To: Liz Aguiar, Principal Planner

From: Scott Backman, Esq., Miskel Backman, LLP  
Christina Bilenki, Esq., Miskel Backman, LLP  
Beth Schrantz, Land Planner, Miskel Backman, LLP

Date: June 24, 2024

RE: Mainstreet at Coconut Creek Site Plan – Block 3

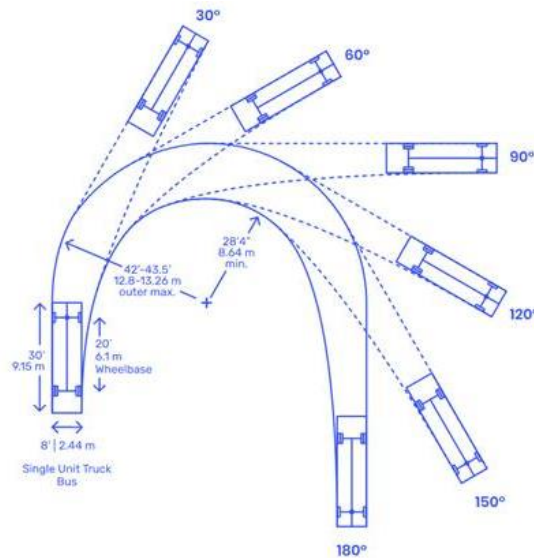
A minimum inner turning radius of 28'4" | 8.64 m should be provided for a bus or single-unit truck making a 180° turn.

**RESPONSE: Refer to the truck turning plan which depicts the bus template routing through the site.**
